Information Report to Planning & Development Committee

Report Number: 06-18

Zoning By-law Amendment Application A 12/17

Brock Dersan Developments Inc.

City Development Department Submitted Conceptual Site Plan

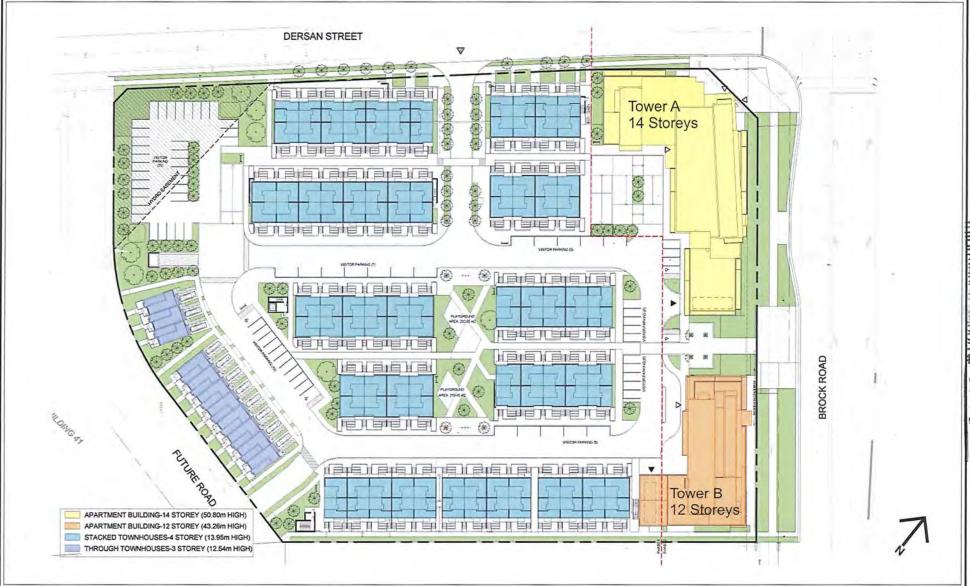
- review the resident and visitor parking standards proposed that are similar to the City Centre by-law and ensure that sufficient parking is provided to support the proposal

- conformation from Hydro required to permit parking within the Hydro easement
- ensure the vehicle entrance to the site is aligned with the future local road location of the development to the west

- evaluate the design of the pedestrian connections within the site and to the transit locations to ensure barrier free path of travel
- assess whether the size and configuration of the proposed private amenity space is appropriate for the proposed development

- ensure an appropriate interface between buildings located on the southerly limits of the subject lands and the Madison development to the south
- review the setbacks between the stacked townhouse buildings
